Agenda Item # 7

SUB-003803-2026

Symone Mixon Subdivision

- Subdivision approval to create two (2) legal lots of record from one (1) metes-and-bounds parcel and one (1) legal lot of record.

DETAIL SITE PLAN

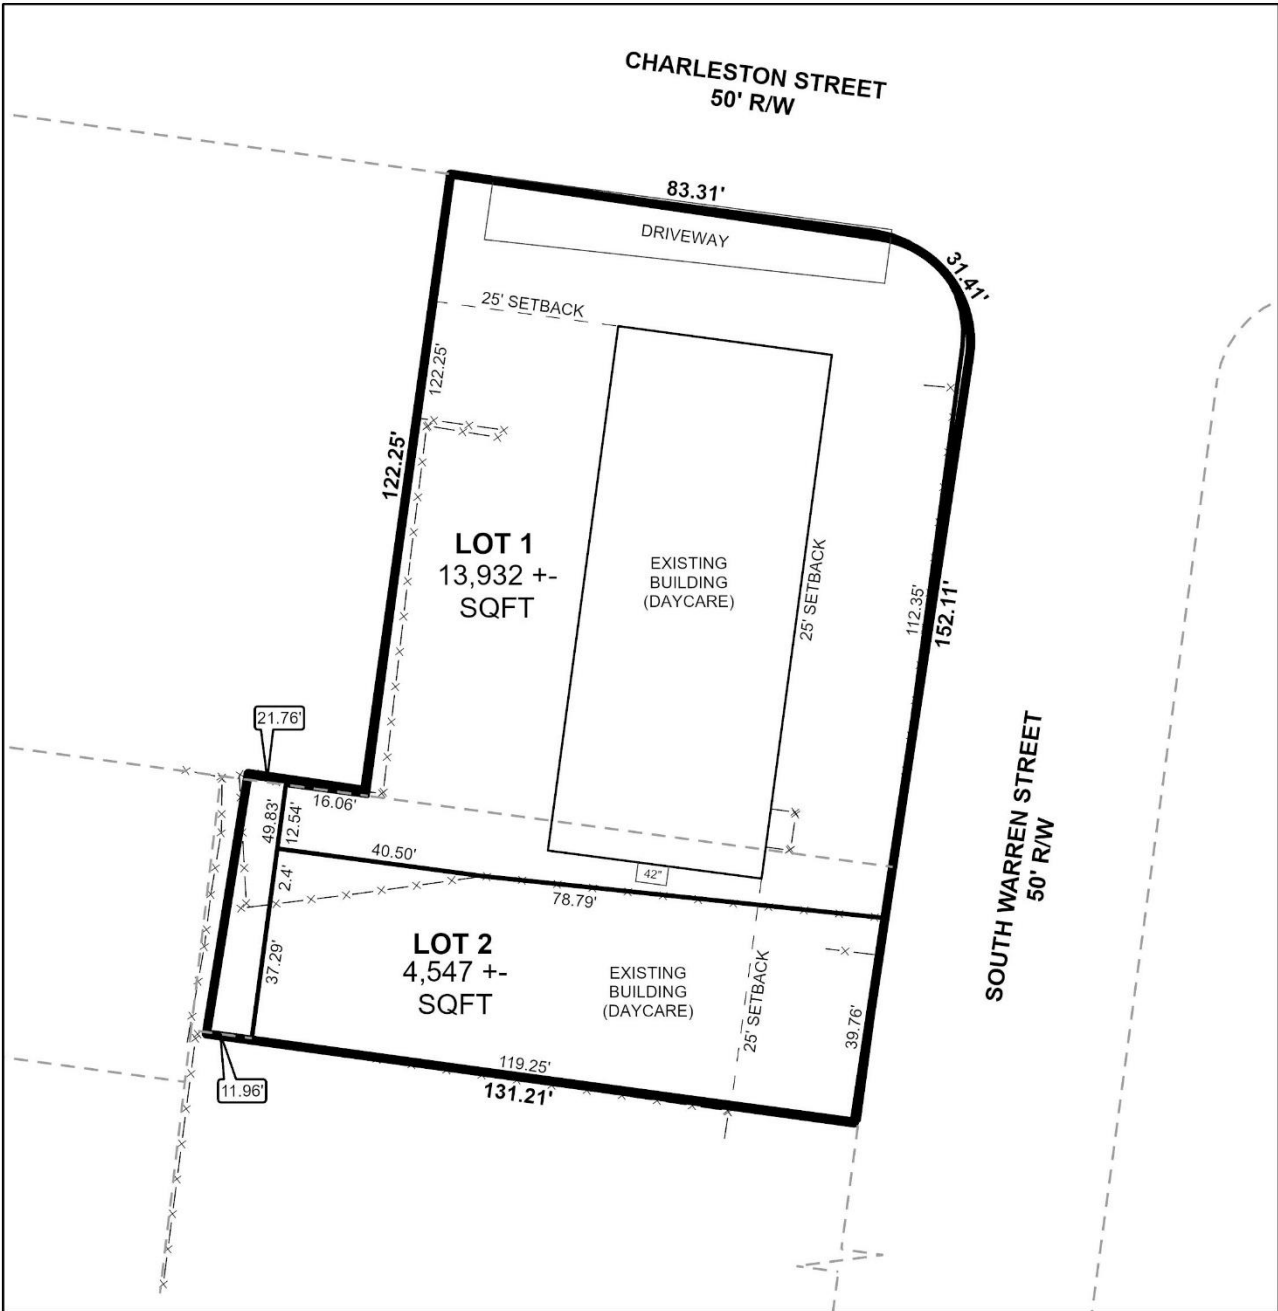
- B. Check the information for Curve #1 and clarify on the plan and in the written description whether it is a 20' radius or a 25' radius.
- C. Check the graphic scale.

- D. Provide the Flood Zone designation in SURVEYOR'S NOTES #6.
- E. Revise ENGINEERING COMMENTS #1 to read "As shown on the 1984 aerial photo LOTS 1 - 2 share the 6,500 sf of historical credit of existing (1984) impervious area towards stormwater detention requirement per Mobile City Code, Chapter 17, Storm Water Management and Flood Control) and share the 8,000 SF credit provided to the original SF residential lot as follows: LOT 1 – 9,000 sf, LOT 2 – 5,500 sf. Stormwater detention will be required for any additional impervious area that exceeds the allowable credit for that LOT.

- F. Revise ENGINEERING COMMENTS #4 from "THAT SIDEWALK..." to "SIDEWALK...".
- G. Retain NOTES 2, 3, 5, and 6.
- H. Email a pdf copy of the FINAL SUBDIVISION PLAT and LETTER OF DECISION to the Permitting Engineering Dept. for review at land.disturbance@cityofmobile.gov prior to obtaining any signatures. No signatures are required on the drawing.

Proposed Lot 1 fronts Charleston Street and South Warren Street, and proposed Lot 2 fronts South Warren Street. Both are minor streets with curb and gutter improvements, each requiring a 50-foot-wide right-of-way. If approved, the 50-foot right-of-way width should be retained on the Final Plat along both street frontages, as illustrated on the Preliminary Plat.

Section 6.C.6. of the Subdivision Regulations requires street intersection corners to have radii of at least 25 feet. The Preliminary Plat includes a table indicating a 20-foot corner radius at the intersection of Charleston Street and South Warren Street, which appears to have been approved as part of the 1971 subdivision. Accordingly, a waiver of Section 6.C.6. will be required. Given that the existing 20-foot radius appears to have been previously approved, the waiver may be appropriate in this case.

It should be noted that the proposed Lot 2 does not meet the 6,000 square foot minimum area requirement of Article 2, Section 64-2-5.E. of the UDC. As such, a waiver of Article 2, Section 64-2-5.E. will be required for approval.

It should be noted that residential lots located within a Suburban designation per the Unified Development Code, shall be at least 60 feet wide at the building setback per Section 6.C.2.(b)(2). of the Subdivision Regulations. The proposed Lot 2 is illustrated with a width of 39.76 feet. As such, a waiver of Section 6.C.2.(b)(2). of the Subdivision Regulations will be required for approval.

An existing commercial daycare building is depicted on Lot 1 of the preliminary plat. It should be noted that Section 64-3-8.A. of the Unified Development Code states that a protection buffer shall be required where any commercially utilized property adjoins a residentially utilized property. A fence is illustrated on the preliminary plat along the north property line of proposed Lot 2. If approved, the fence should be retained on the Final Plat.

A dwelling is visible in recent aerial and street-view imagery on proposed Lot 2. The structure does not appear to meet the required setbacks and may exceed the maximum permitted lot coverage, which could constitute a nonconforming condition. If the structure is to remain, it should be depicted on the Final Plat. Otherwise, the plat should include a note indicating that the structure will be demolished with the required permits.

1. Retention of the 50-foot right-of-way width along Charleston Street;
2. Retention of the 50-foot right-of-way width along South Warren Street;
3. Retention of the lot sizes in both square feet and acres, or provision of a table on the Final Plat with the same information;
4. Retention of the illustrated protection buffer between Lots 1 and 2;
5. Revision of the plat to depict the existing structure on Lot 2, or provision of a note stating that the structure will be removed pursuant to the required demolition permits;
6. Compliance with all Engineering comments noted in this staff report;
7. Placement of a note on the Final Plat stating all Traffic Engineering comments noted in this staff report;
8. Compliance with all Urban Forestry comments noted in this staff report; and,
9. Compliance with all Fire Department comments noted in this staff report.
